Economic Commission for Europe**Inland Transport Committee****Working Party on Customs Questions affecting Transport****Group of Experts on Conceptual and
Technical Aspects of Computerization of the TIR Procedure****First session**

**eTIR conceptual, functional and technical specifications version 4.3:
Amendments****Amendments to the eTIR conceptual, functional and
technical documentation - v.4.2a****Note by the secretariat****I. Introduction - Mandate**

Figure I
Guarantee state diagram

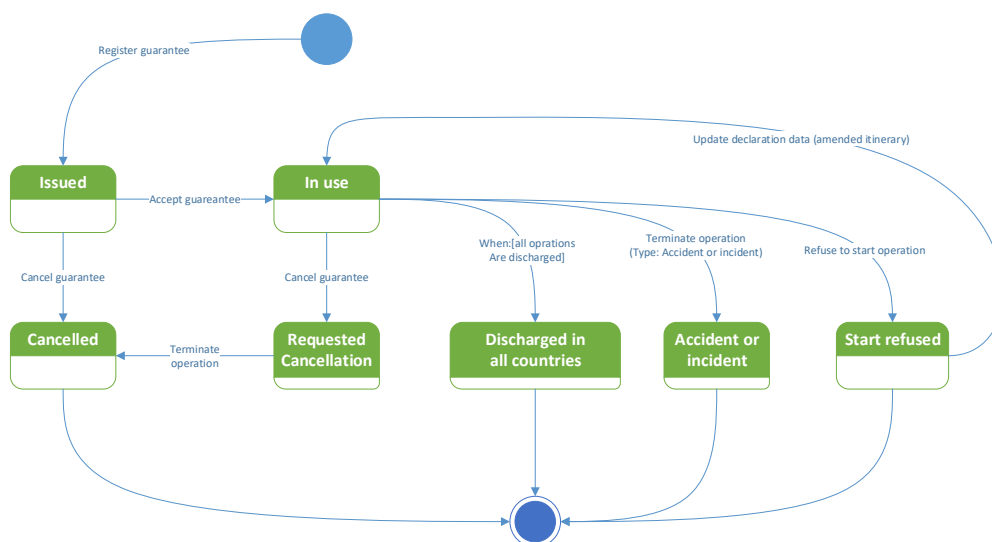
36. Figure 1.12 (Refusal to start TIR operation sequence diagram) in the eTIR functional specifications document shows that after the reception of a refusal to start message (I17), the eTIR international system cancels the guarantee. However, when revising Figure 3 (Guarantee status chart diagram) of the eTIR concepts document, GE.1 agreed to the additions of a new “final” status (start refused) for the guarantee should be used following the reception of a refusal to start message (see ECE/TRANS/WP.30/2020/7, para .7).

37. In the course of the informal preparatory meeting, the Experts were of the view that the “start refused” status should be kept and, also, should not be a terminal status, but instead, if the transport is in a position to return to the departure under the cover of the same guarantee, the status of the guarantee could return to “in use” after the first operation of the return trip had started. Would the Group of Experts agree with this view, Figure 3 (Guarantee status chart diagram) of the eTIR concepts document should be changed in line with the picture below and the descriptions, activity diagrams and sequence diagrams related to the Refusal to Start and Update declaration data use cases amended accordingly.

38. The Group of Experts might wish to consider this discrepancy and instruct the secretariat on how to resolve it.

Figure II
Code list 12

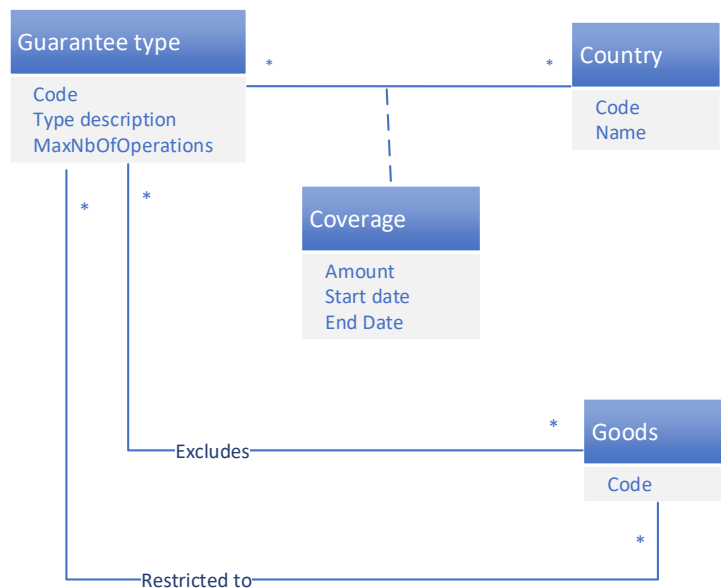
54. Figure 1.16 of the eTIR functional specifications document version 4.2, clearly shows that the guarantee type shall also be defined with respect to their geographical coverage as well as with regard to the limitations or exclusions about goods. With regard to the geographical coverage, the eGuarantees types above will be restricted to the eTIR pilot project countries. Regarding the exclusion of goods, they should exclude tobacco and the relevant alcohol products.

55. Figure 1.16 also shows that currently the “guarantee type” table also includes an “amount” attribute. However, in view of the current application of the TIR procedure, moving the “amount” attribute to the “coverage” association between “guarantee type” and “country” will allow to record that the maximum amount covered by the guarantee chain can vary between countries. Moreover, including a start and end dates to that association class would also allow to record that the maximum amount covered can vary over time. Finally, replacing the goods description by the goods code would model more precisely which goods are excluded from a guarantee type or the goods that a guarantee type is restricted to. The class diagram below shows how these changes could be reflected in Figure 1.16:
